IRS405A-AK VER:0D CHANGE TO 01 NOTE

BY : Rank	
MOTOTEHC	
Title	
IRS405A-AK	
Size	Document Number
B	CHANGE NOTE
Date:	Rev
November 08, 2004	01
Sheet 7 of 7	
1

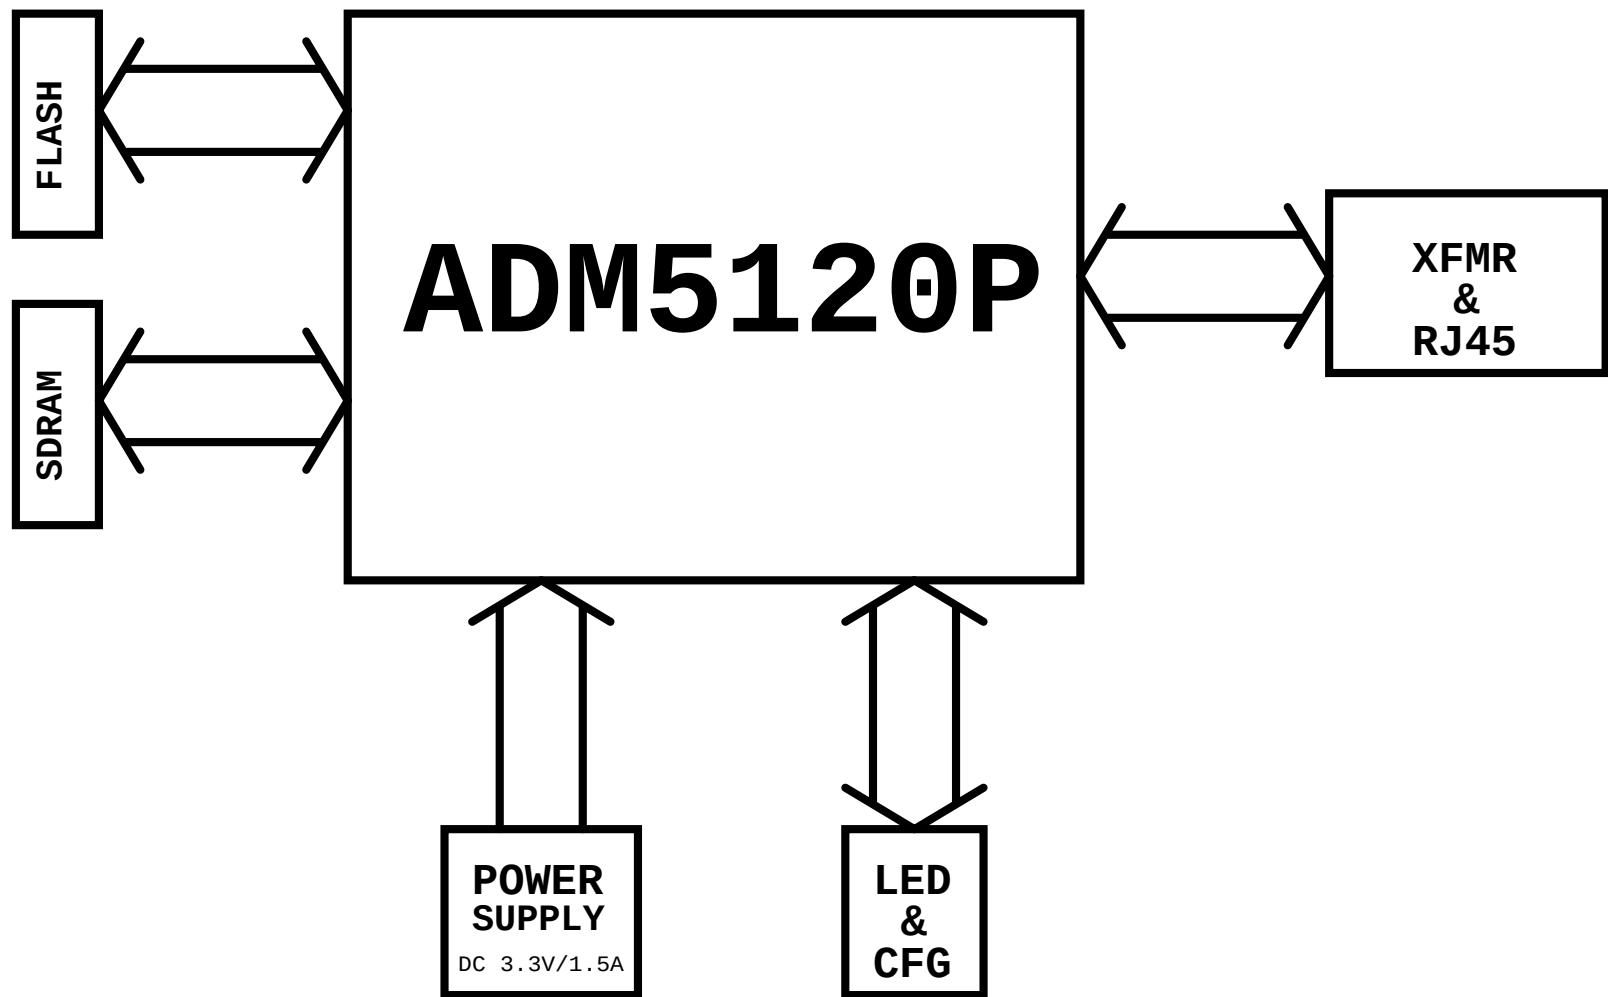
- 1. Move C106 to far away C88 for manufacture issue
- 2. Update PCB version to R01
